# BZA #20382

# Parties in Opposition

June 23, 2021

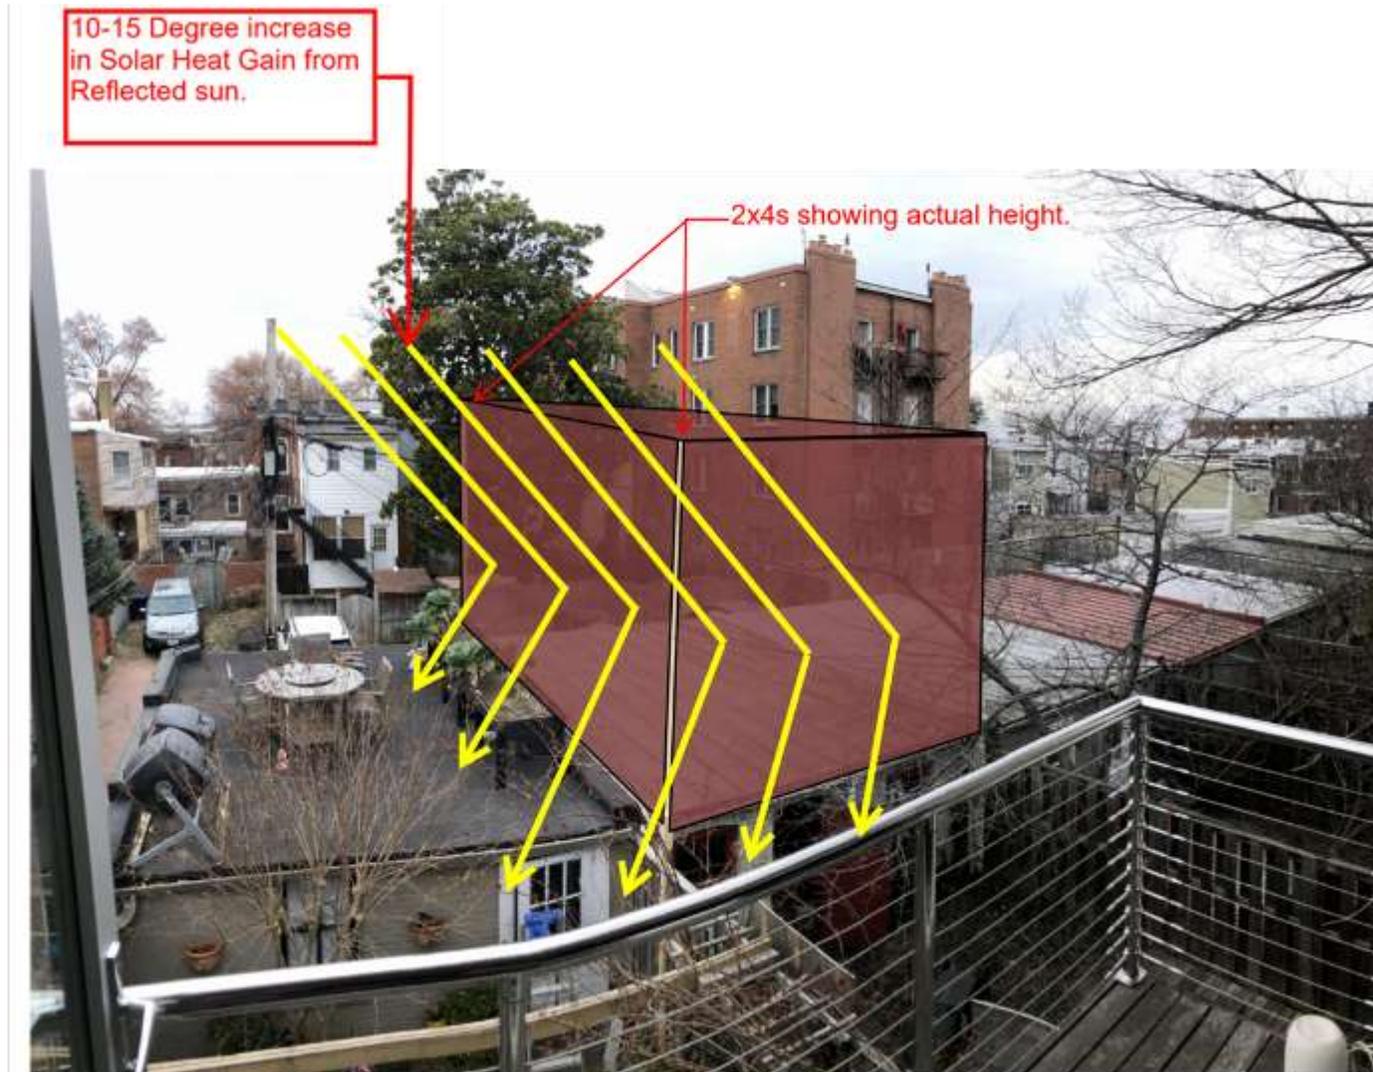
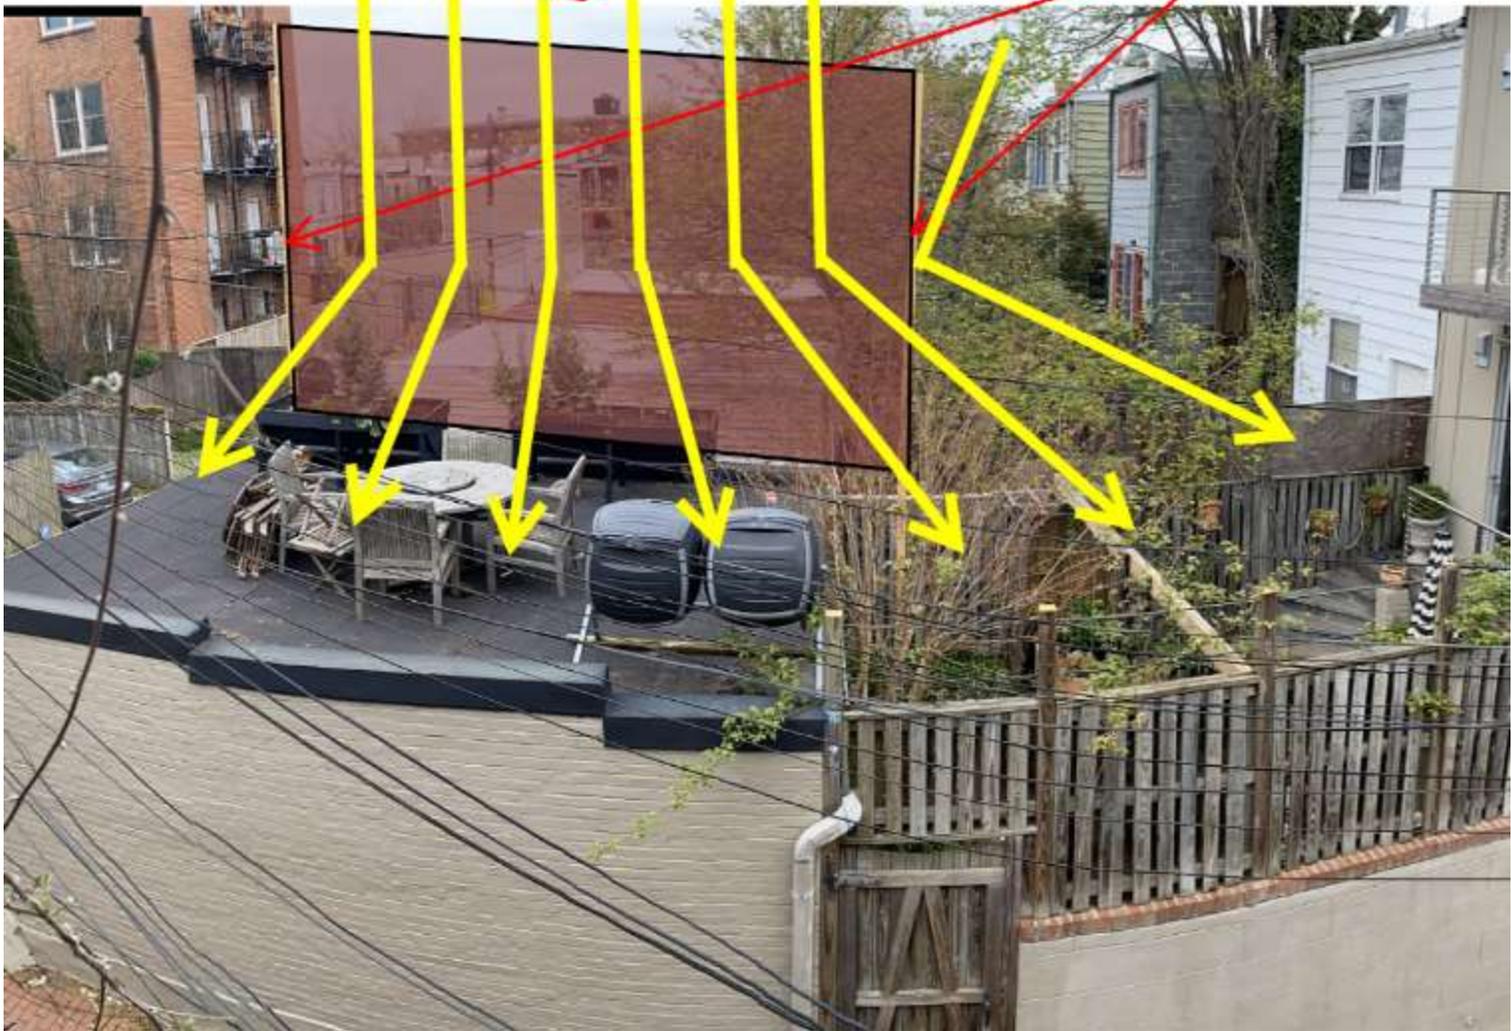
- High Thermal Mass means heat absorbent
- Significant heat gain during day (faces directly east and south)
- Blocked air current prevents cooling to mitigate heat gain and release through day and night

10-15 Degree increase in Solar Heat Gain from Reflected sun.

Existing Permit B2007169

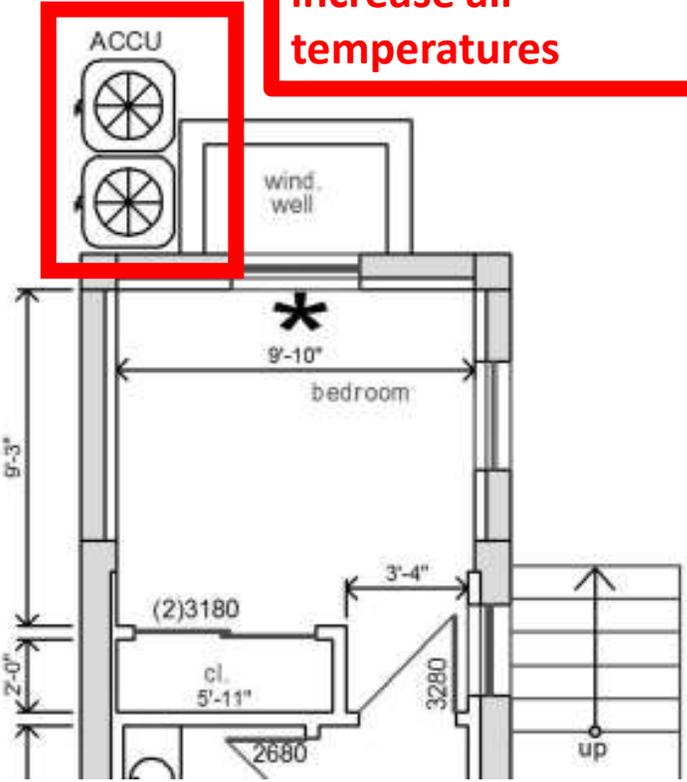
2 new AC units adjacent to Howell Residence will further increase air temperatures
